The Port is seeking non-material variations to the project’s Marine Construction Licence in accordance with section 30(7) of the Marine Scotland Act 2010. This document sets out the details of the requested variations and explanation of their non-material nature.

Document ID 400.DWT/Docs/SPA/Marine Licensing	Date Revised 27-08-24	Review date N/A	Page No. Page 1 of 9
---	---------------------------------	---------------------------	--------------------------------

DEEP WATER TERMINAL PROJECT**REQUEST FOR NON MATERIAL VARIATION TO MARINE CONSTRUCTION LICENCE****APPENDIX 1****INDICATIVE DETAILS OF FLOATING LINKSPAN**

BOLLARD ISLAND
GENERAL ARRANGEMENT

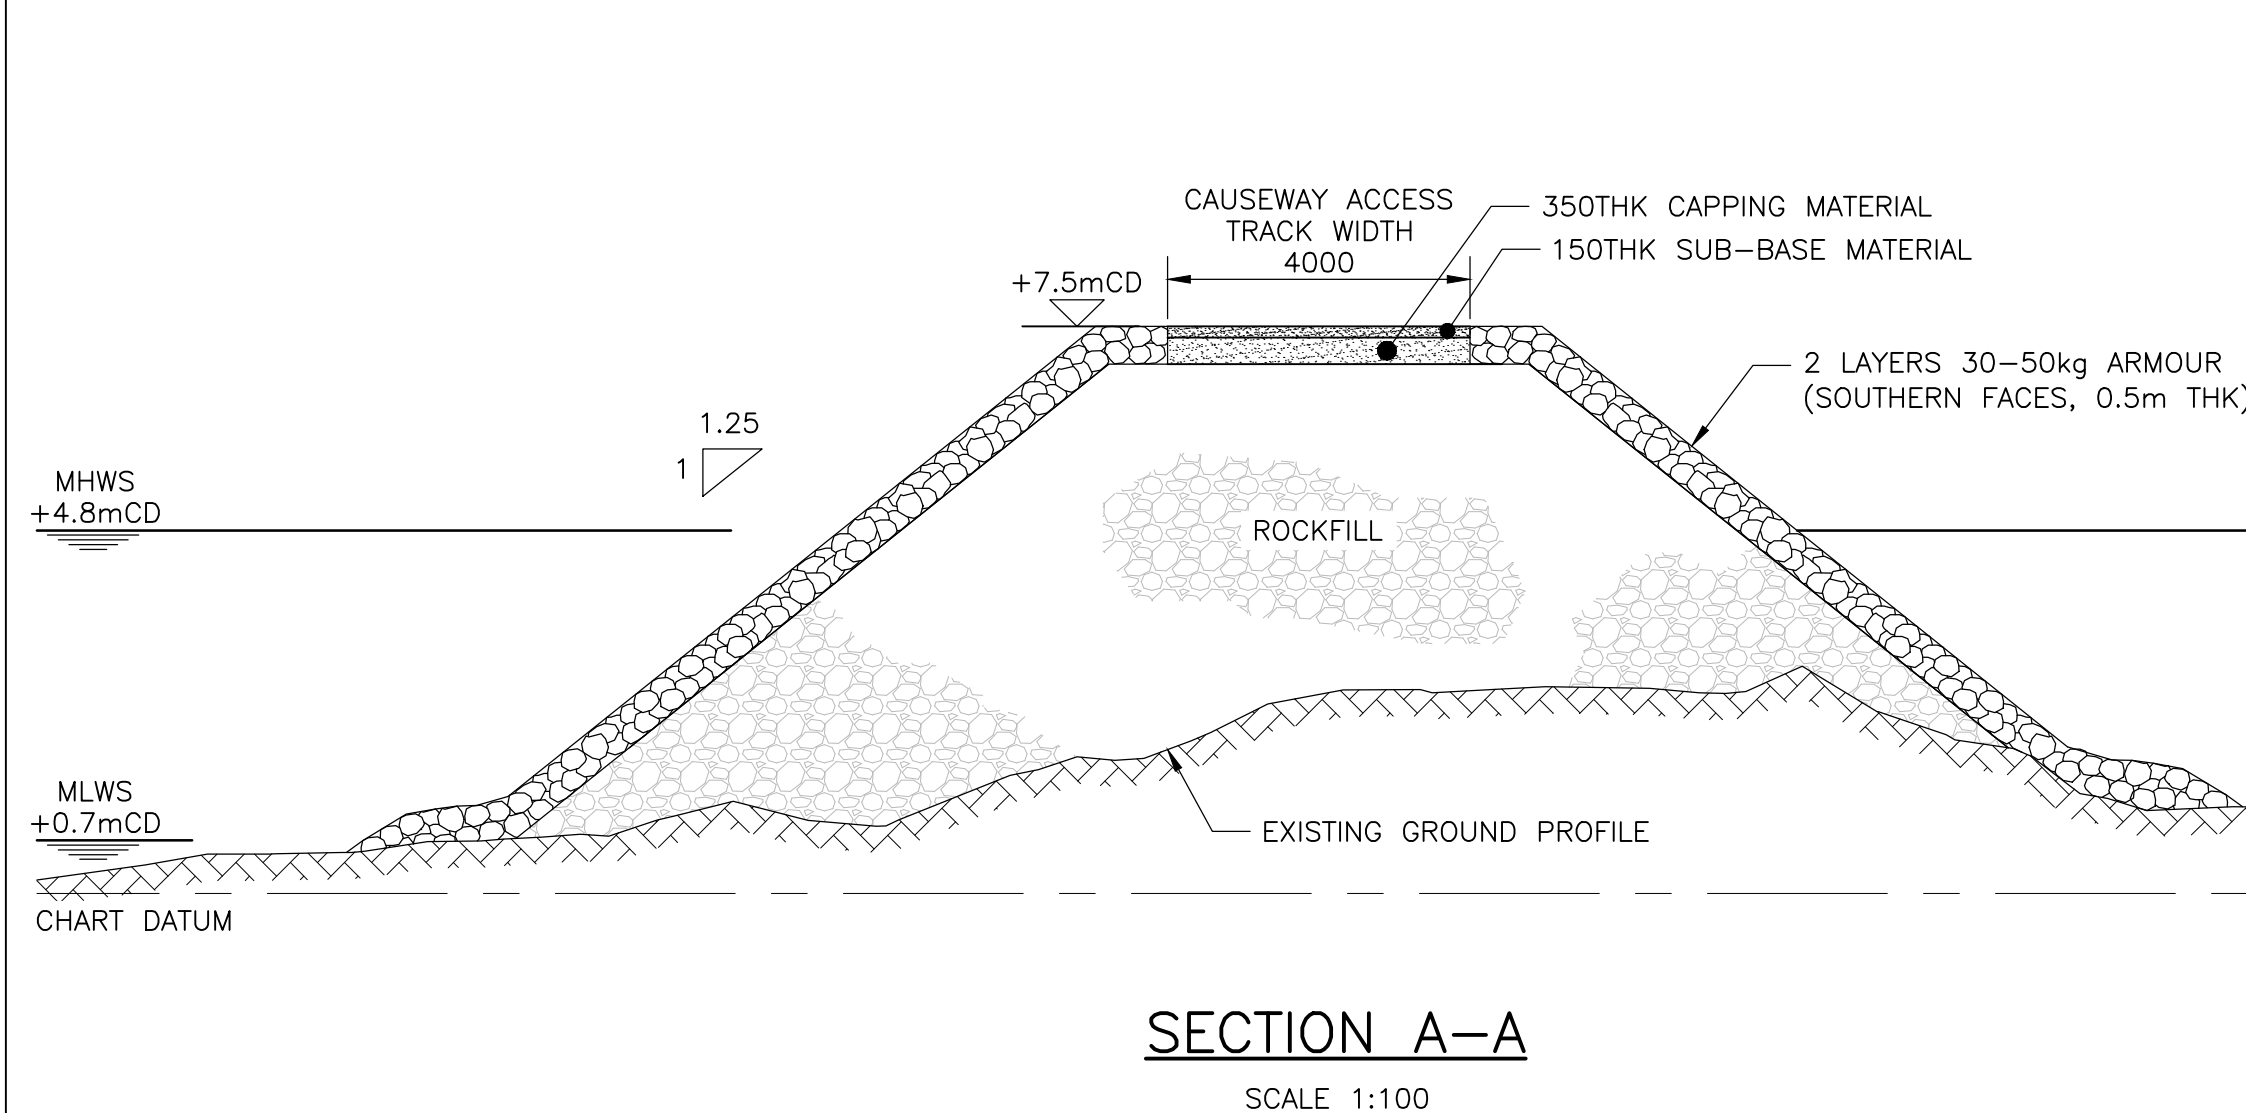
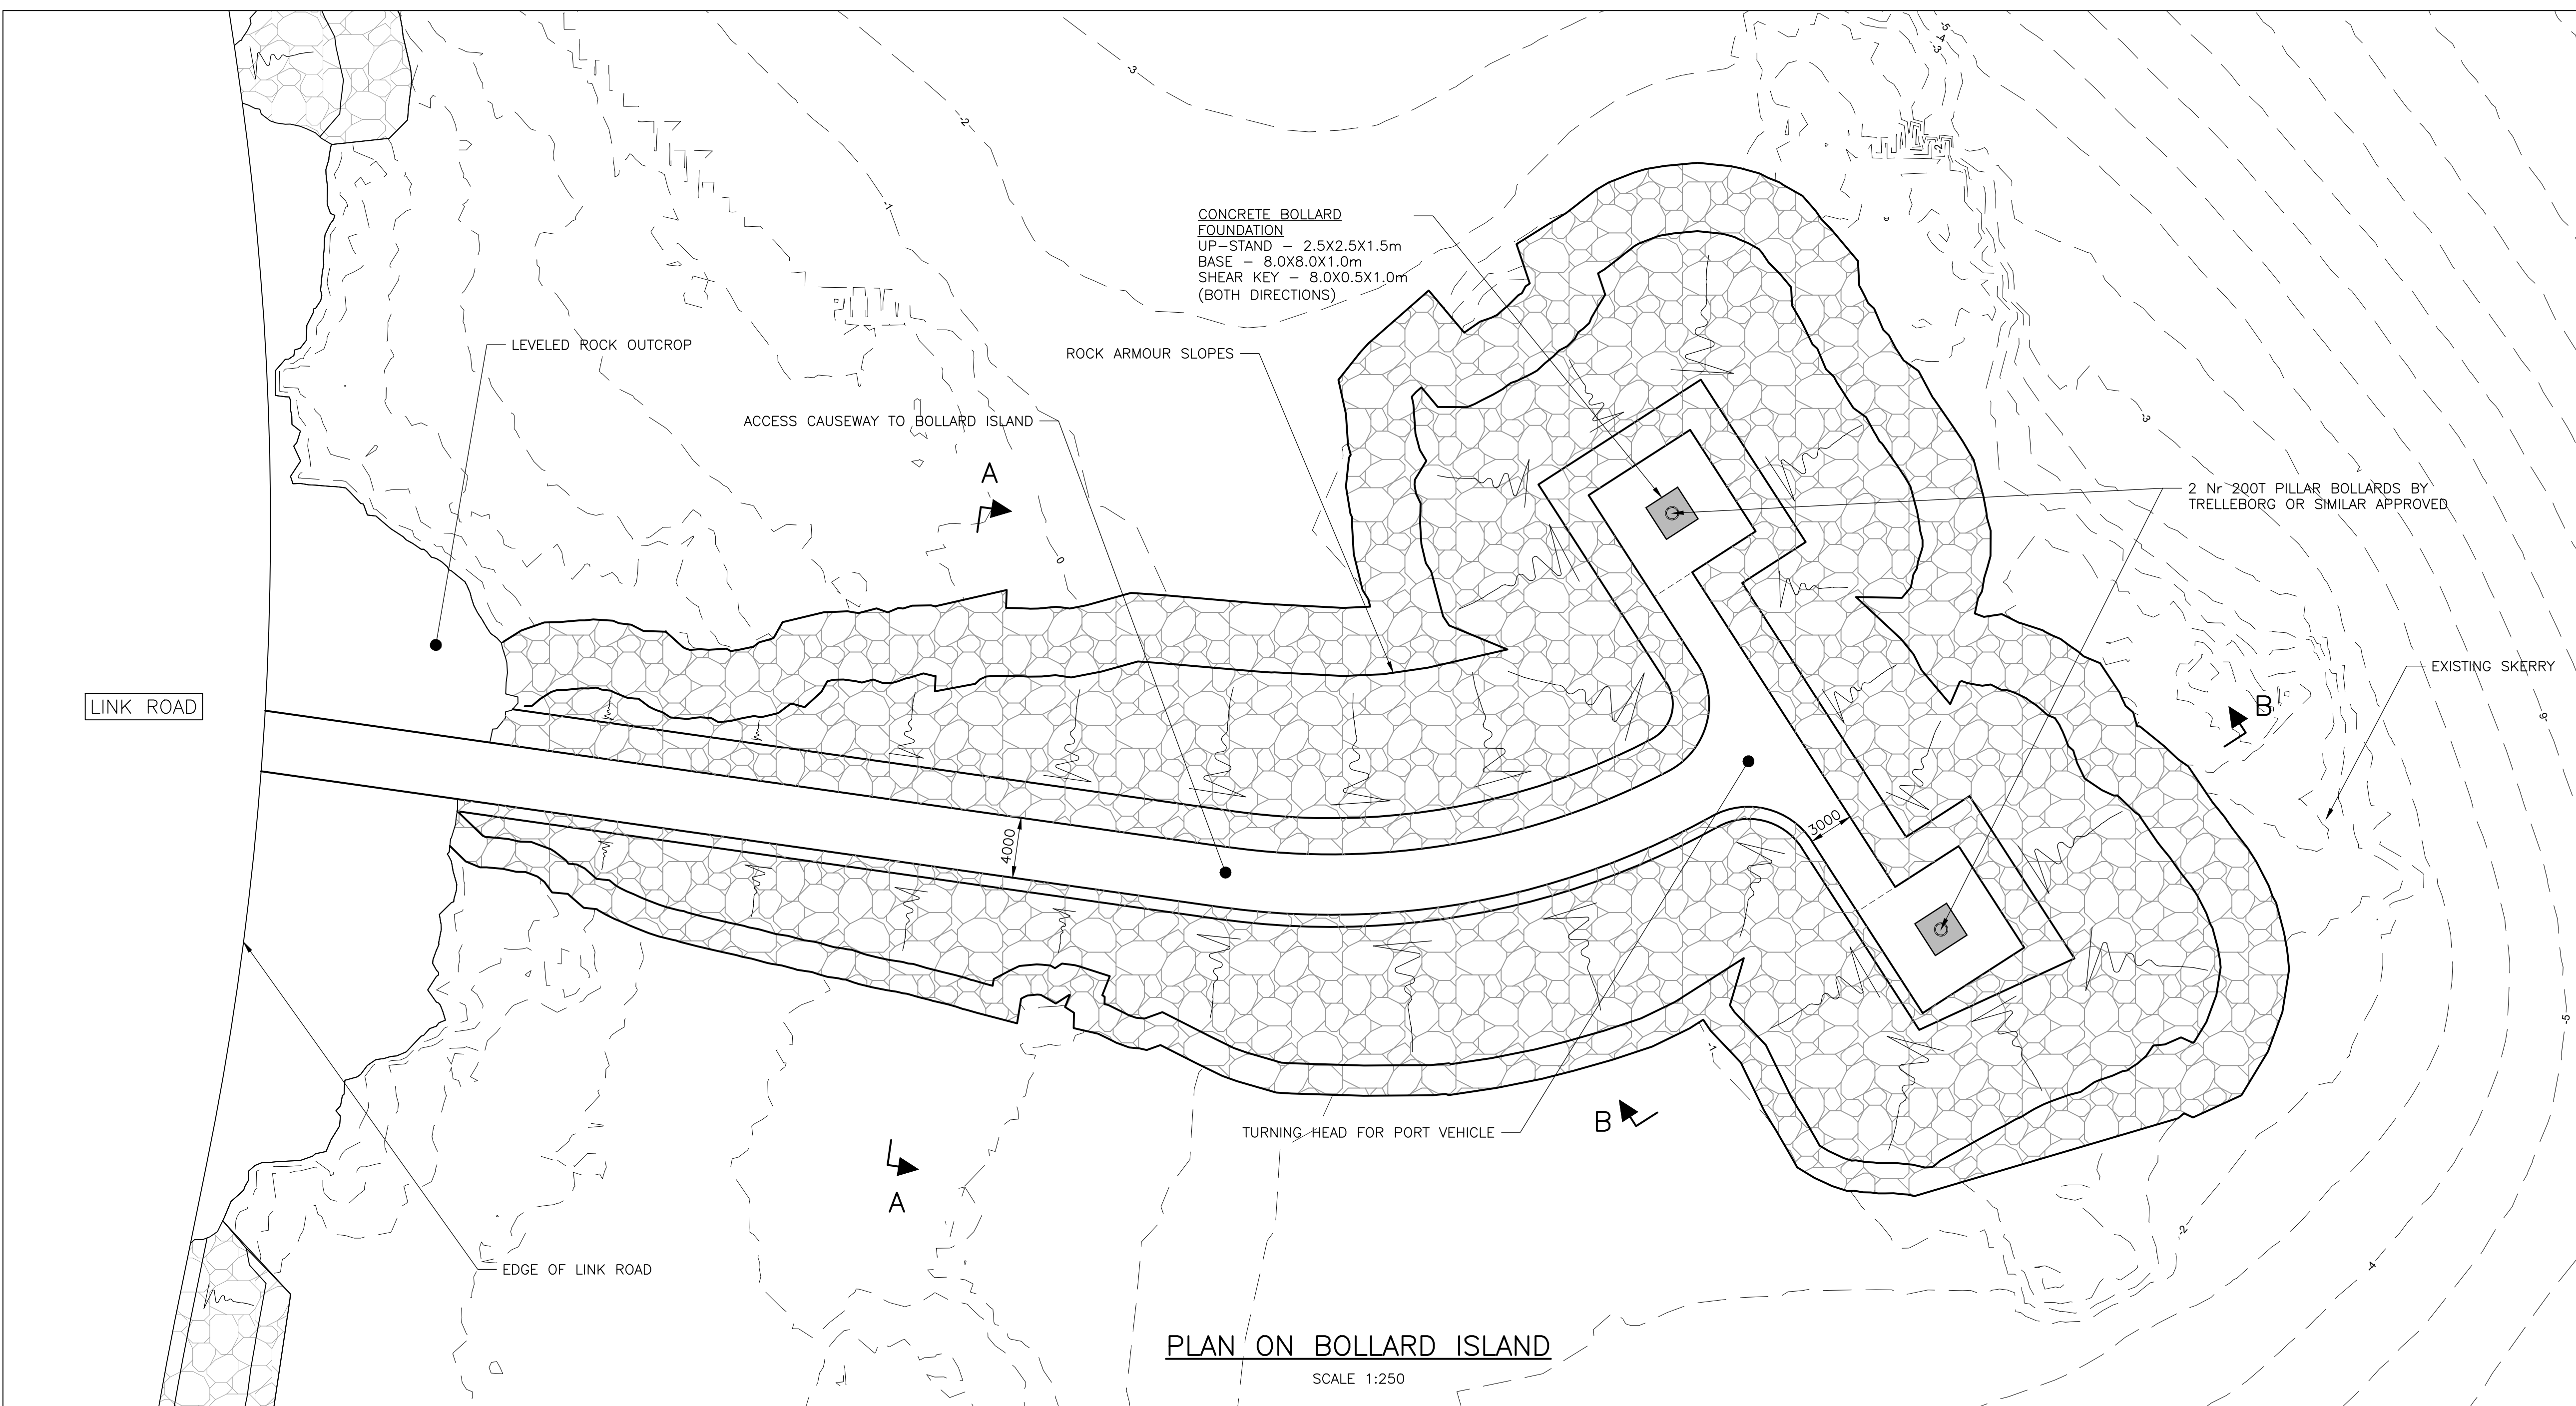
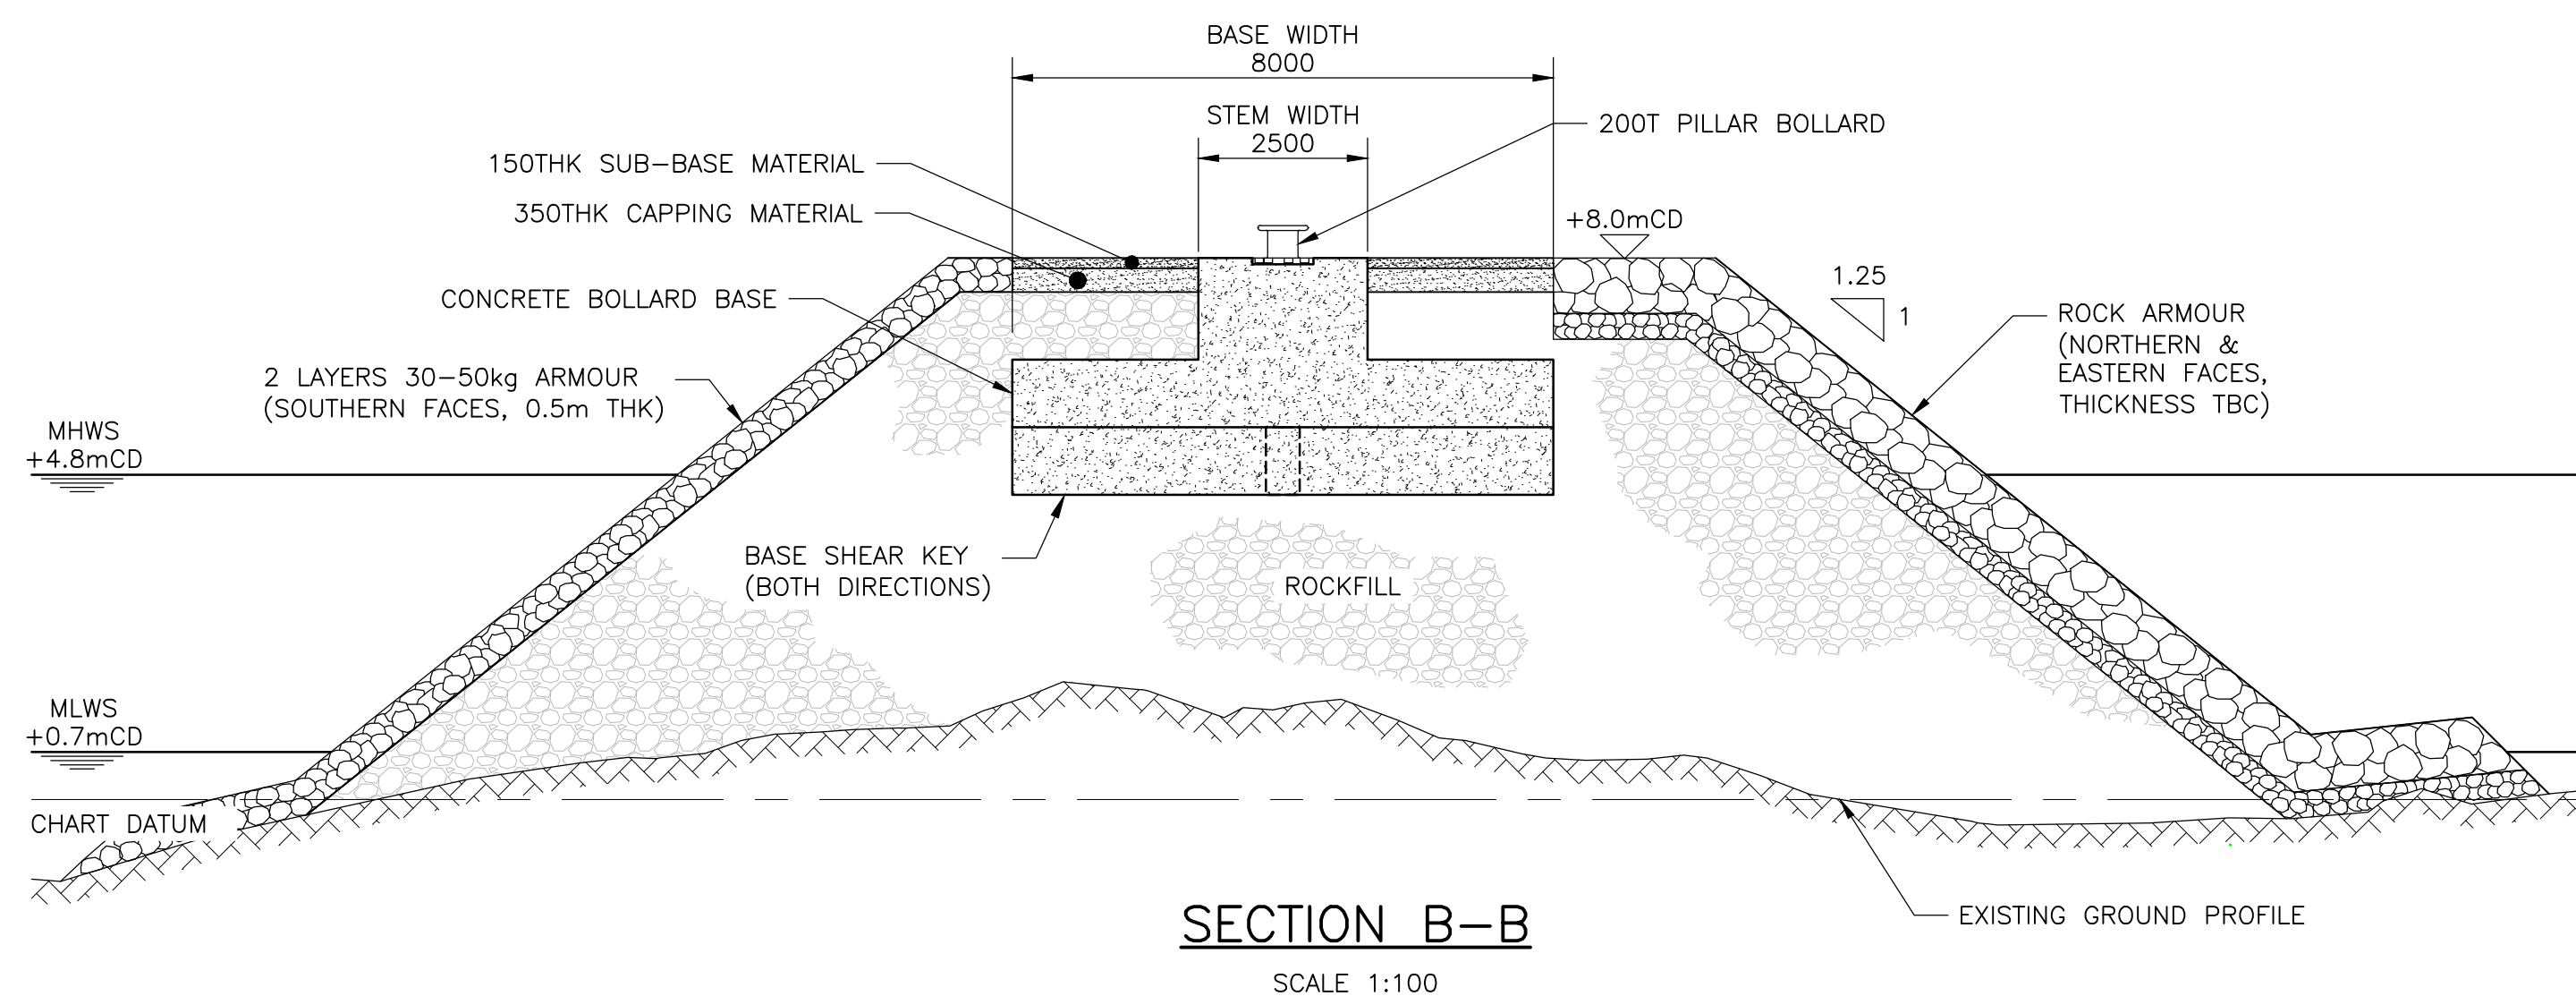
As part of this design review, the Port will omit part of the consented works, namely part of the 15m wide by 114m long finger pier and the whole of the proposed ‘bollard island’. The remaining 16m length of the proposed finger pier has been constructed as a stand-alone marine structure. Details of these works are set out in Section 4 below.

secured to the seabed by steel toe pins grouted with concrete into holes drilled into the bedrock		
2	98m length of finger pier	Open piled 15m wide pier comprising 800mm tubular steel pies driven into the seabed rock driven by vibrating hammer as far as possible, then by impact hammer	18 No. 800mm diameter steel piles	The finger pier was omitted following a design review, which identified that only part of the finger pier was required.
3	Bollard island	Bollards secured to rock outcrops with 4m access causeway approximately 100m long formed of rock bund protected by rock anchor	Rock fill Rock armour	Plan of bollard island included at Appendix 6.
